Research Report 1546

MANPRINT Evaluation of the High Mobility Multipurpose Wheeled Vehicle—Heavy Variant (HMMWV—HV)

February 1990

Figure 14. Ramp for loading and unloading litters

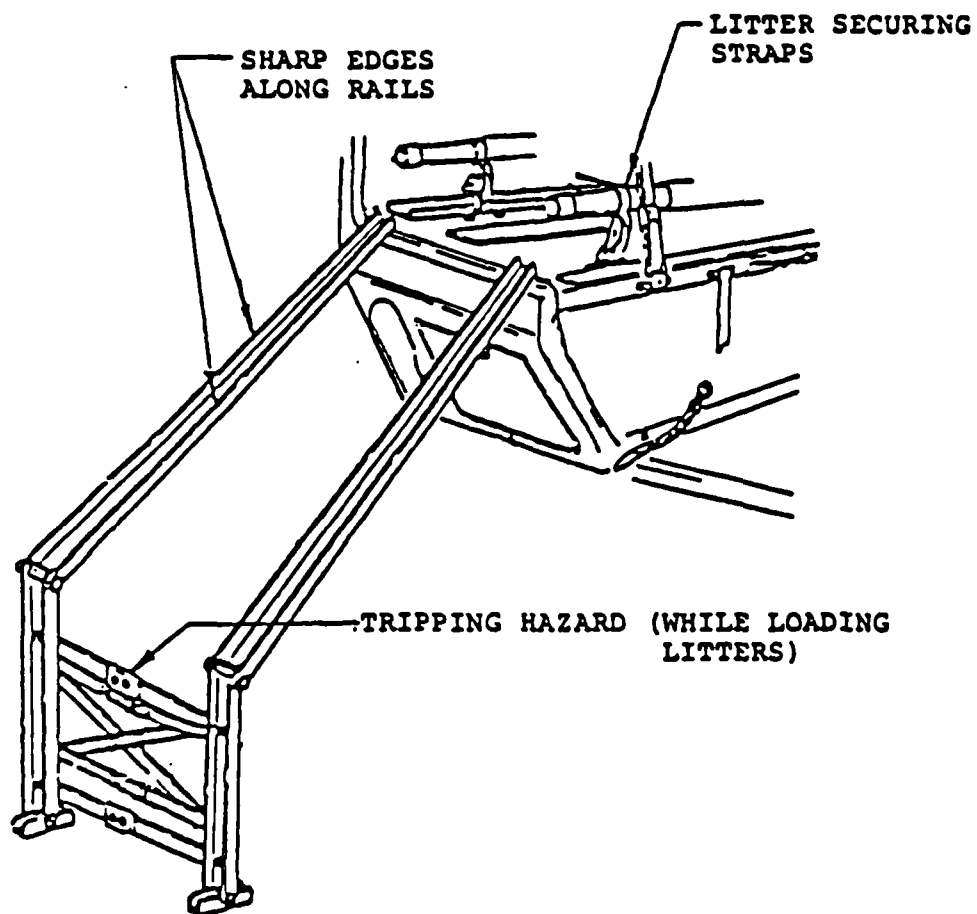
Probable cause. The litter bearers' ability to load and unload litters is decreased by (see Figure 14):

Potential solution. Litter ramp rail edges should be rolled. The litter ramp attachment to vehicle lugs should be altered to increase their ability to stay secured. Loading procedures should be revised to have litter bearers load litters using a side-carry loading method. This method would avoid the litter ramp structure tripping hazard and would also allow for both litter bearers to apply the lifting and pushing forces required to load the litter.

Incorporate a litter-securing device that first clamps to the litter, and second, allows litter securing tension to be applied.

Figure 15. Side-mounted rear view mirror

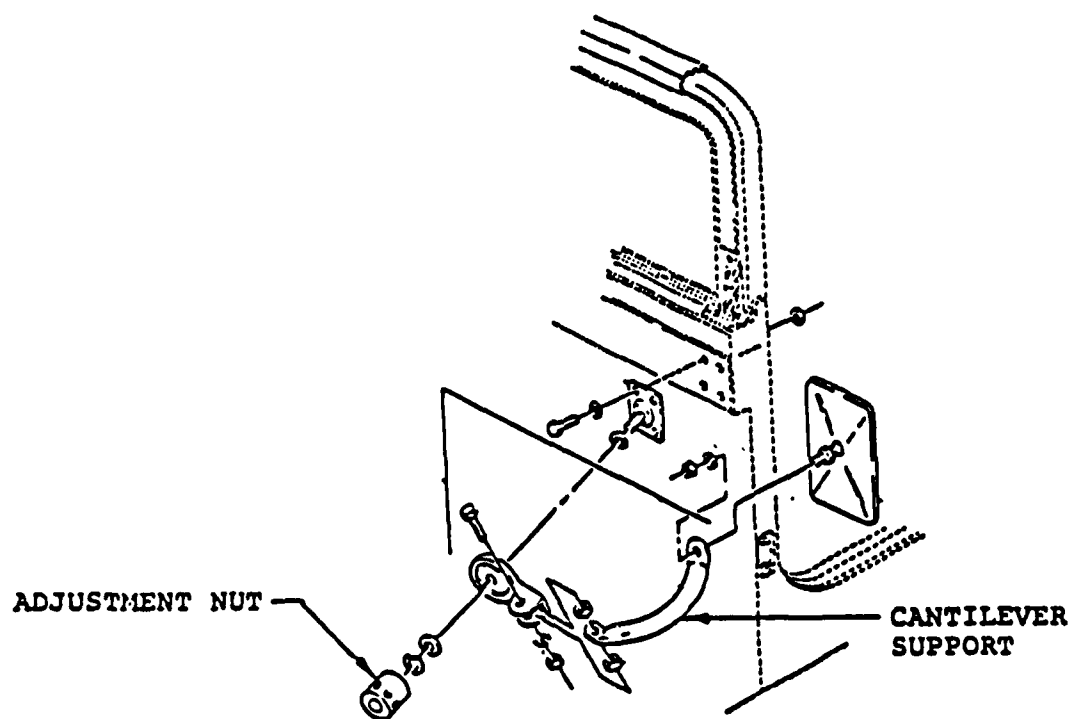
Description of the problem. The side mirrors on the HMMWV ambulances and shelter carrier are too small and vibrate excessively. The hardware for mirror adjustment to the window frame mount vibrates loose, and the mirror falls to the side of the vehicle due to the length of the support. Operators claim the passenger side mirror is poorly positioned and does not provide a view. Shelter carrier drivers complain they do not have adequate rearward view to monitor their trailer status.

Probable cause. The mirror is supported by a single support that is approximately 20 inches (50 cm) long and is cantilevered from the mounting and adjusting hardware (see Figure 15). Vibration acting on the same plane as the adjustment nut tends to loosen the nut.

Increase size of mirrors. Crewmen would prefer mirrors similar to those found on M35, 2.5-ton vehicles.

Figure 16. Pioneer tool rack attachment

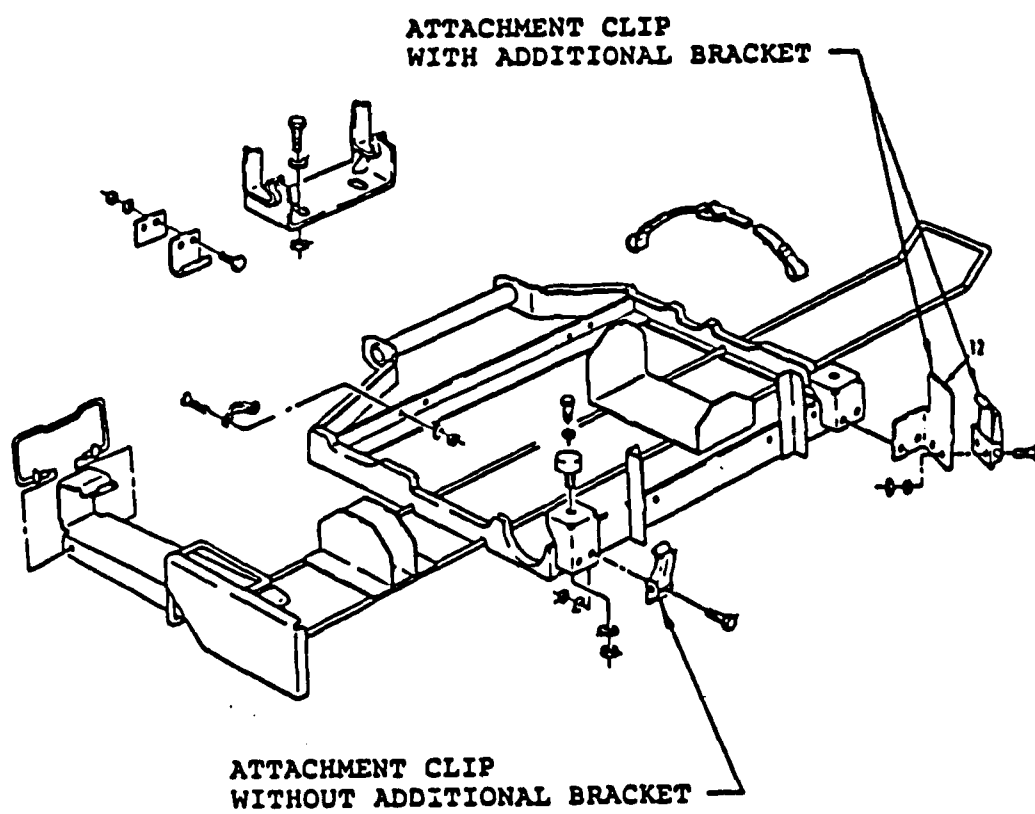
Description of the problem. The standard pioneer tool racks that fit the HMMWV cargo or tow will not fit the HMMWV-HV ambulances or shelter carrier. Racks furnished for the ambulances or shelter carrier come with a special angle bracket to adapt the pioneer tool rack to these vehicles (see Figure 16). One ambulance (B02) was issued a standard pioneer tool rack (including tools) which would not fit beneath the ambulance. These tools were stowed inside the ambulance compartment, interfering with personnel movement inside the compartment.

Potential solution. Attach an adaptor bracket to the HMMWV-HV vehicle instead of the rack so all pioneer tool sets are universal.

Figure 17. Shelter mounting kit

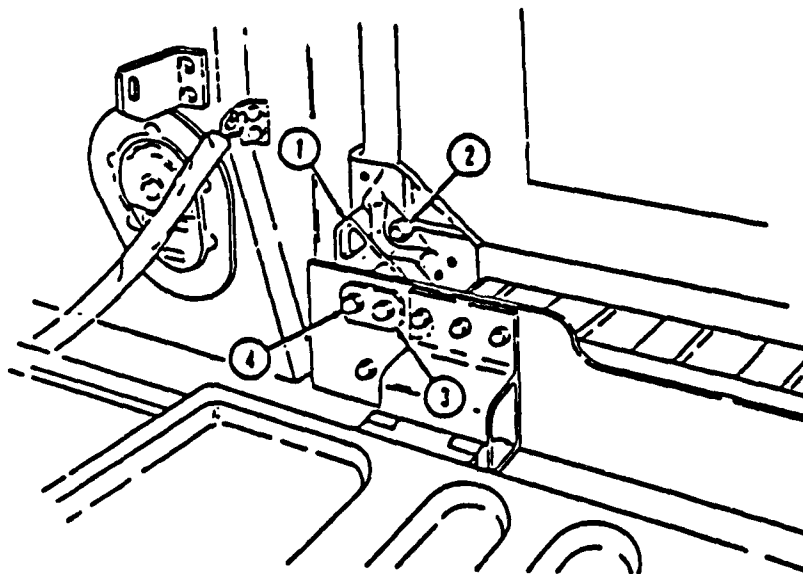
Description of the problem. The mounting kit provided to adapt the S-250 shelter to the HMMWV-HV is not usable for all versions of the S-250 shelter. The mounting kit bolts (Figure 17, Items 2 and 4) behind the cab and passenger seat are difficult to align and start.

Potential solution. Design the shelter mount to accommodate both versions of the S-250 shelter. Instruct personnel to remove passenger seat when installing the shelter on the HMMWV-HV.

Figure 18. Oxygen bottle racks

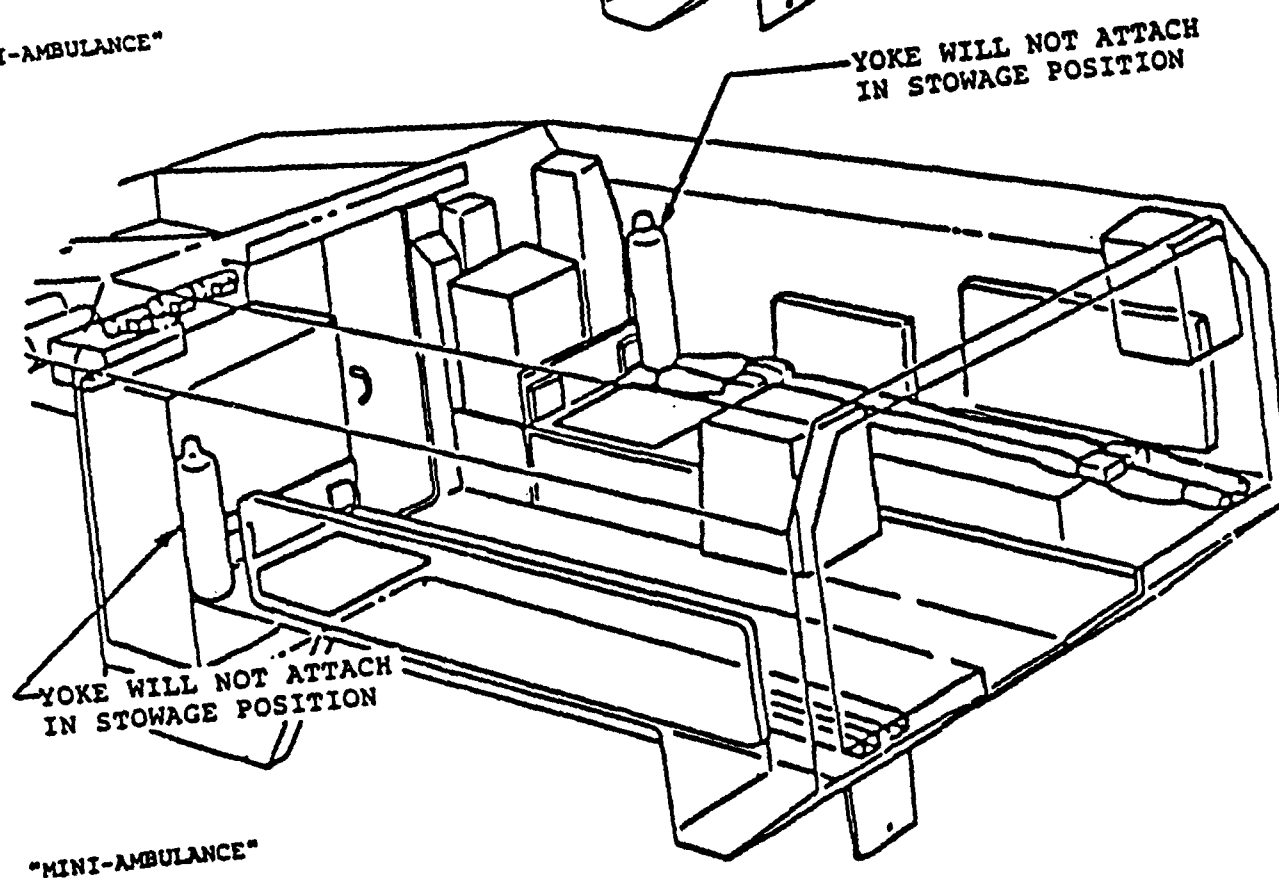
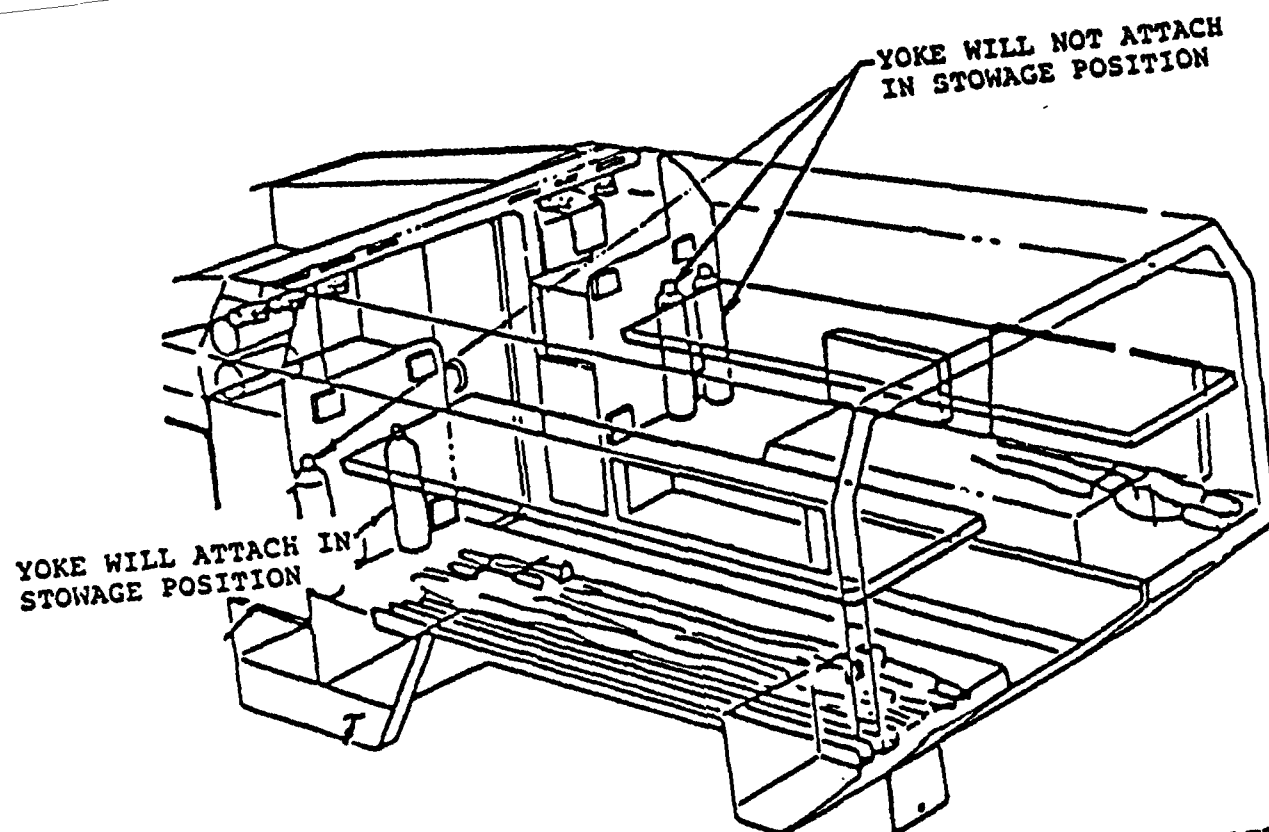
Description of the problem. The oxygen bottle rack mounts position the bottles without enough room to allow for the attachment of the yoke adapters. Bottles cannot be put into service in stowed position at present. Only one rack position in the maxi-ambulance (see Figure 18) will allow the O₂ bottle to be made ready (with the yoke attached) for operation while in the stowage rack. There are no provisions to secure oxygen bottles to litters if the oxygen bottles are placed next to patients on litters.

Potential solution. Redesign racks with sufficient clearances. Design storage rack straps to also serve as oxygen bottle litter-securing straps.
